No. 6-GJC065/2018-BHO/461

Sub: Diversion of 22.80 ha Protected Forest land for construction of cement concrete road with other underground amenities like water supply, Drainage, Storm drainage line, Street light etc. and allied works from Pal(RTO) Hajira Road to Palanpore gam Canal culvert and on both side of existing canal from Pal-Palanpore- Bhesan Gauravpath to Vanakala Jakatnaka (up to outer ring road) in favour of Executive Engineer, Road Development Department, Surat Municipal Corporation in surat District of Gujarat.

Figure: DSS view of Proposed Land for CA

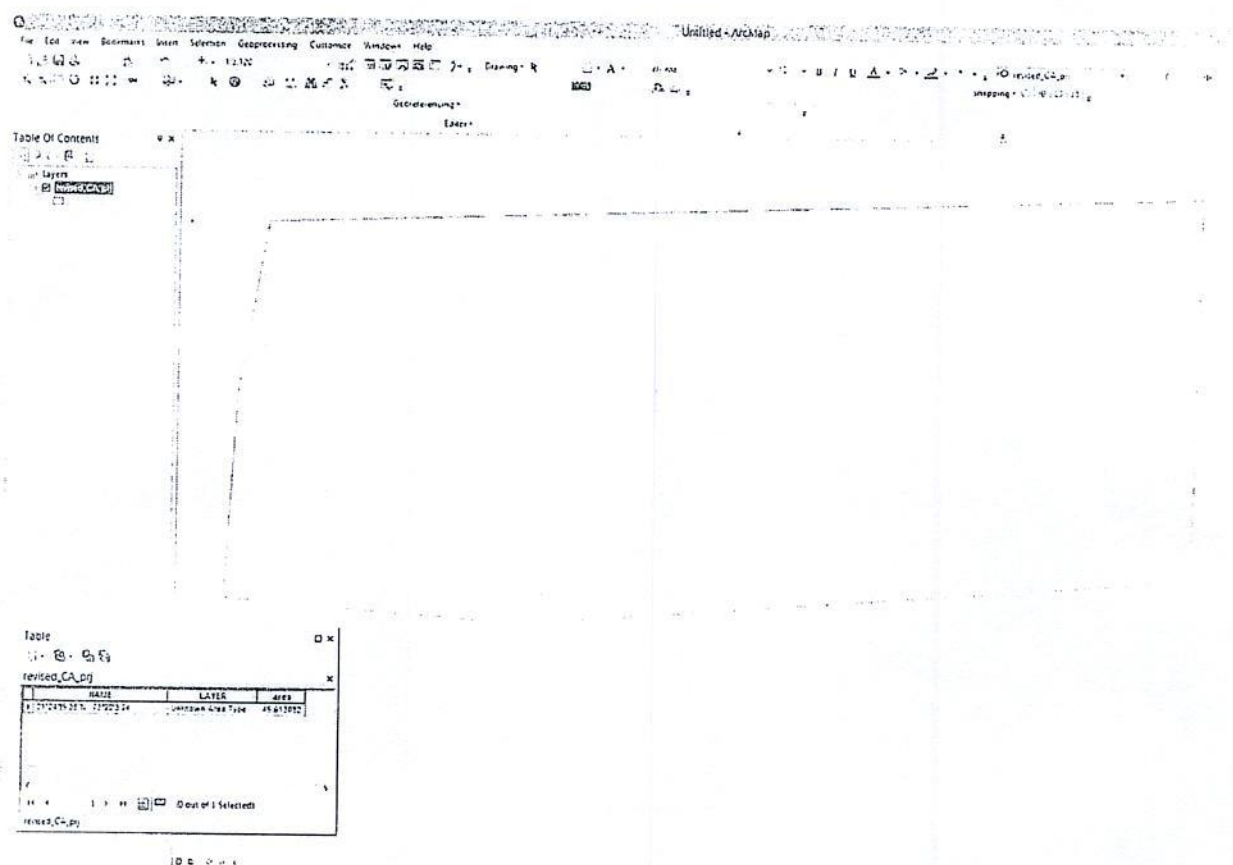
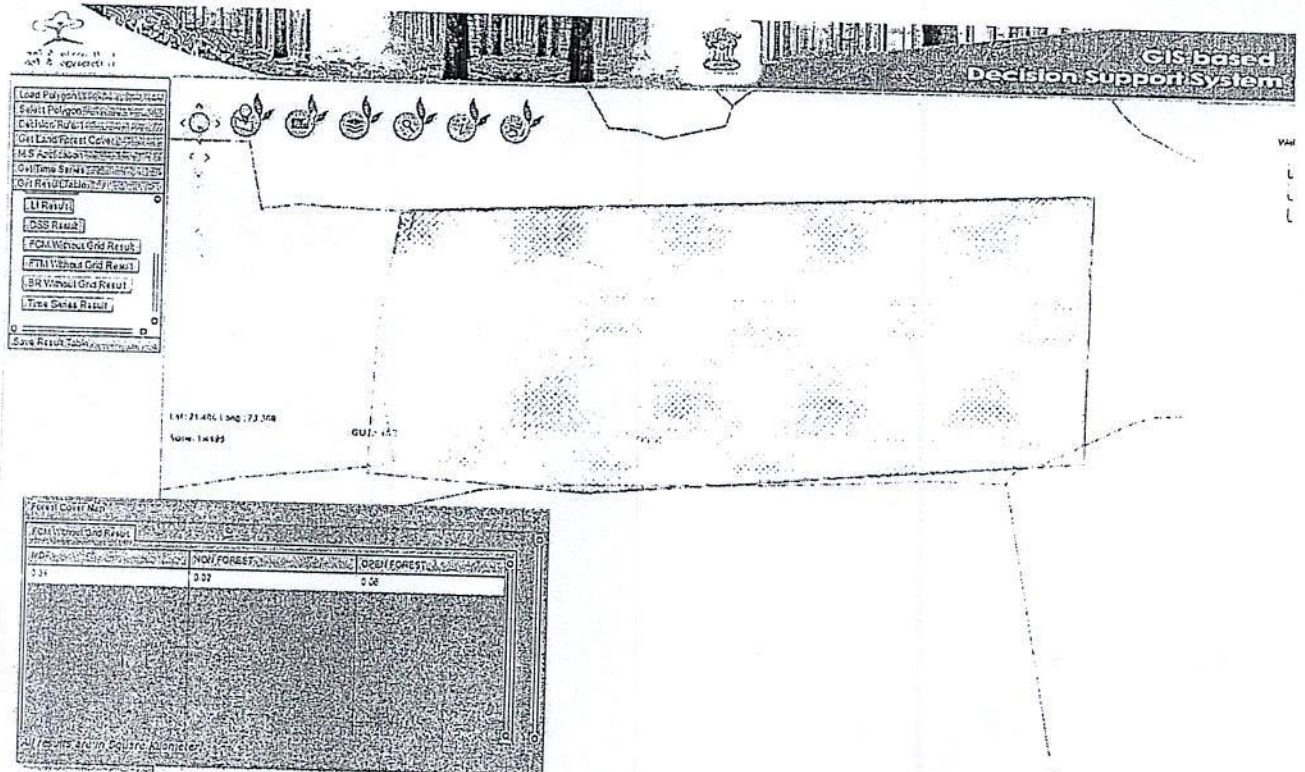
With reference to above mentioned subject and letter under reference, I am directed to inform you that the revised CA land submitted & uploaded comptt. No. 136(663) Pt, Village-Petarkui, Taluka-Mandvi, District-Surat, as per DSS analysis the 38.00 ha is MDF out of 46.00 ha.

Further, kindly revised CA land detils (map & CA scheme) in open forest with C.D<0.4 as per the latest FSI report shall be submitted and uploaded on e. portal.
